RAILROAD COMMISSION OF TEXAS

RE: Sandow Mine, Permit No. 1F
Response to Conditional Approval of Revision Nos. 29, 30 and 31

RE: Sandow Mine, Permit No. 1F
Revision No. 29 - Incidental Boundary Revision (IBR)
Revision No. 30 - Postmine Land Use Plan Revision
Revision No. 31 - Bond Map Revision ✓

SUBJECT: Alcoa Inc. (Alcoa)
Sandow Mine, Permit No. 1F
Revision No. 29 - Incidental Boundary Revision (IBR)
Revision No. 30 - Postmine Land Use Plan Revision
Revision No. 31 - Bond Map Revision ✓

145-B1

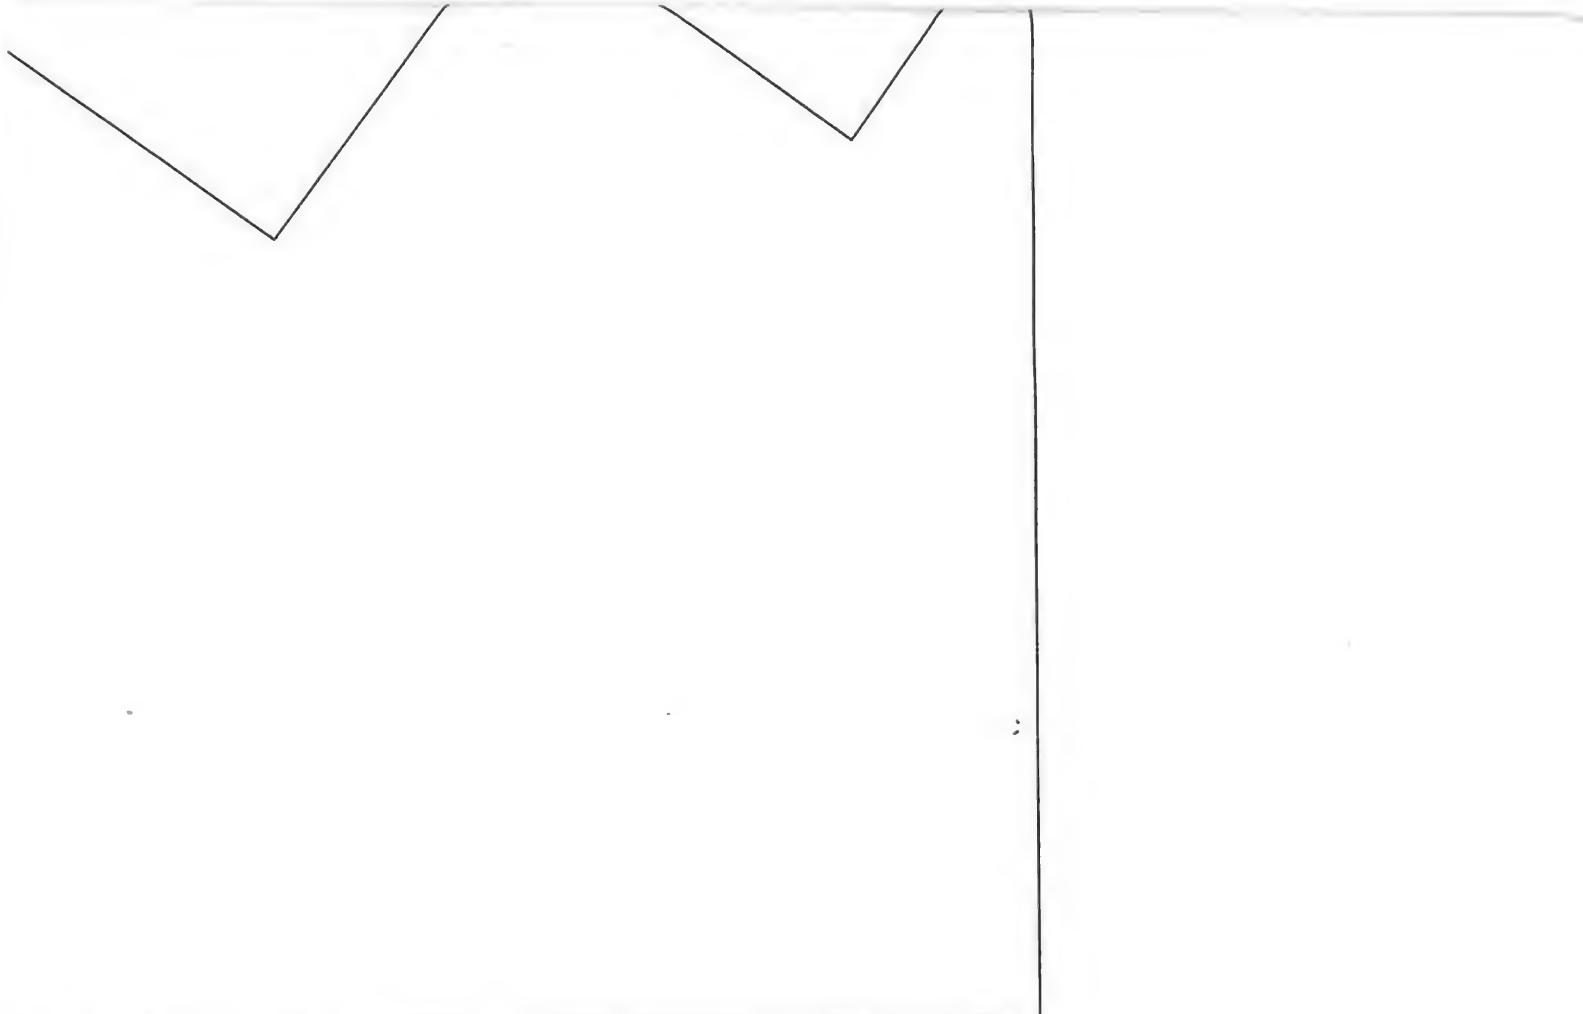
- Within 30 days of this letter, revised bond maps (Dwg. Nos. 145-B1, *North Area Proposed Bond Map*, and 145-B2, *South Area Proposed Bond Map*) must be provided that clearly distinguish between Phase I (mined rate) and Phase I (disturbed rate) areas. The revised maps should also include hatching that clearly identifies Phase III bond release areas since most are surrounded by bonded areas.

15. The bond change maps, Drawing Nos. 145-B3 and 145-B4, included in this application show the proposed bond category change areas. Alcoa requests an addition of approximately 463 acres of undisturbed area to the disturbed rate category. This 463-acre area was previously inadvertently removed from the approved bond maps and reclamation cost estimate. This error is corrected and the area is shown on the bond maps as being bonded at the disturbed rate. The revised bonded areas are accounted for in Alcoa's revised reclamation cost estimate. Staff notes that the bonding categories shown on the revised bond maps are difficult to distinguish in some areas. Specifically, it would be helpful if the Phase I bond release areas were shown in a manner that allows Staff to identify whether the areas were originally bonded at the mined or disturbed rate. Additionally, several small Phase III bond release areas are identified by a light gray hatch pattern. These areas are also difficult to see in some places because of a lack of contrast with surrounding areas.

- Within 30 days of this letter, Alcoa should be required to provide revised bond maps (Dwg. Nos. 145-B1, *North Area Proposed Bond Map*, and 145-B2, *South Area Proposed Bond Map*, dated revised May 23, 2012) that clearly distinguish between Phase I (mined area) and Phase I (disturbed area) areas. The revised maps should also include hatching that clearly identifies Phase III bond release areas.

Alcoa provided revised bond maps Drawing Nos. 145-B1, *North Area Proposed Bond Map*, and 145-B2, *South Area Proposed Bond Map*, dated July 23, 2012. The bond maps clearly distinguish between Phase I (mined rate) and Phase I (disturbed rate) areas. Although still difficult to easily discern, the Phase III release areas are identified with grey solid hatch. The revised bond maps (dated July 23, 2012) adequately address the conditional approval of Revision No. 29 through 31 and are acknowledged.

Alcoa Inc., Sandow Mine received your letter dated July 24, 2012 regarding Alcoa's Revisions 29, 30 and 31. You requested that Alcoa provide revised bond maps that clearly show the difference between Phase 1 Mined Rate and Phase 1 Disturbed Rate bonding, along with areas that have received Phase III release. Three copies (3) of Drawing Numbers 145-B1 and 145-B2 are provided with this letter.

DWG. NO. 145-B3

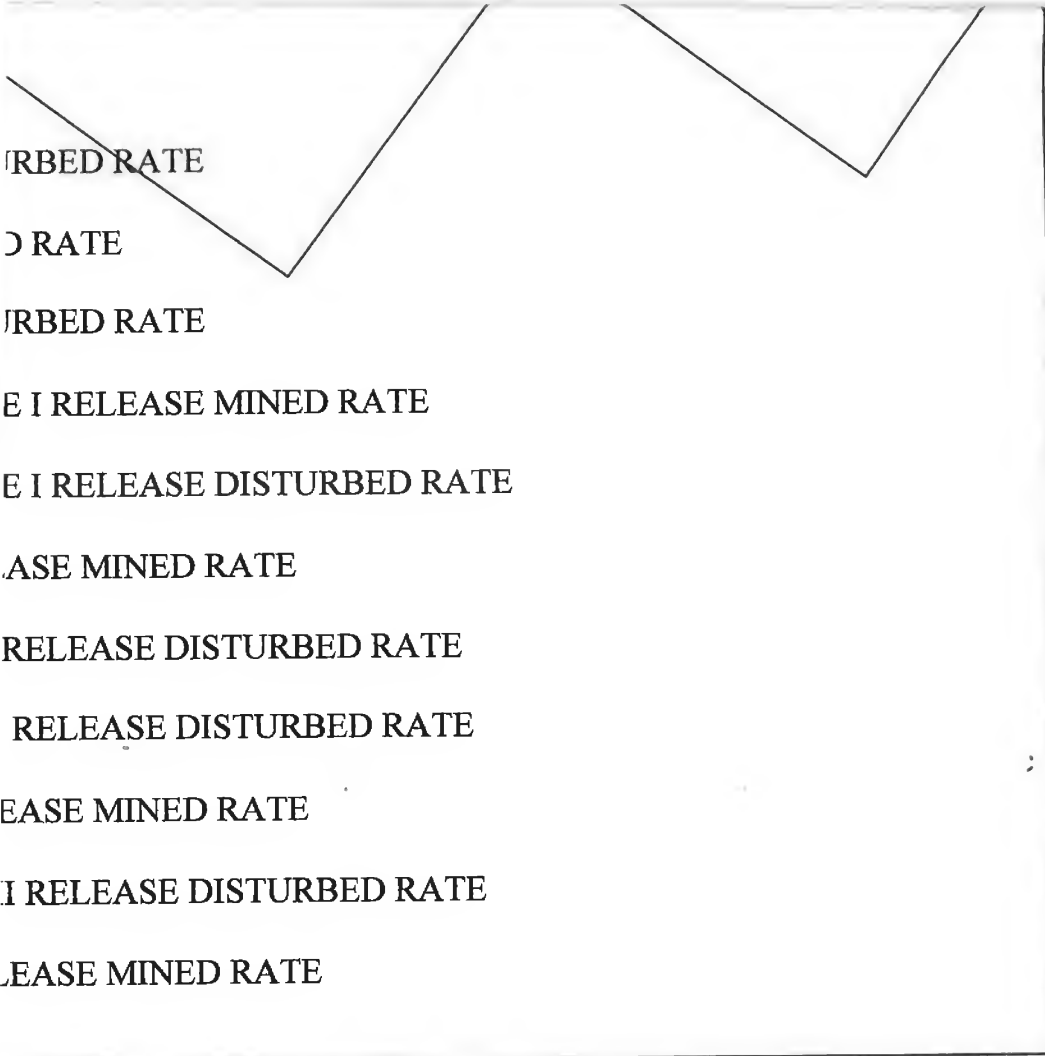
1. Alcoa indicates that a disturbed portion of the H-Area was inadvertently considered as undisturbed and removed from the approved bond maps. Comparison of the approved bond maps (Revision No. 17, approved administratively by letter dated August 22, 2011) and the proposed revised bond maps (Drawing Nos. 145-B3 and B4) revealed several areas, in addition to the correction in the H-Area, that are either being added or removed from the bonded area. These areas are described in the following table:

Alcoa must provide a bond change map to facilitate field verification of the proposed changes.

Alcoa Inc, Sandow Mine received your letter dated may 25, 2012 regarding our submittal of revised bond maps for the Sandow Mine. Alcoa has reviewed the areas noted in your letter and made appropriate revisions to correct mapping errors that were found during this review process. Alcoa provides with this response, revised Drawings 145-B3 and B4 that show the bond change categories as requested. These maps show all areas proposed to change from the approved bond map, including those granted various phases of bond release granted since the approval of Revision 17, as well as those areas that have modifications to the bonding rates or categories. Also provided with this response are two drawings, noted as 145-B1 and 145-B2, which show the same bonding information without noting the changes referenced above. These maps show only the appropriate bonding level for each category (mined or disturbed) and the various phases of bond release previously approved by the Commission. Alcoa has also updated the estimated bond calculation based on the changes that occurred as a result of this review, with an estimated bond amount of \$45,818,746 required to cover the final reclamation activities of Sandow, inclusive of the 10% administrative fee. Alcoa does not request a revision to the approved bond instrument of \$56,000,000 at this time. All drawings referenced in this response are provided in electronic format as well as the bond calculations. Should you have any additional questions, please do not hesitate to contact me.
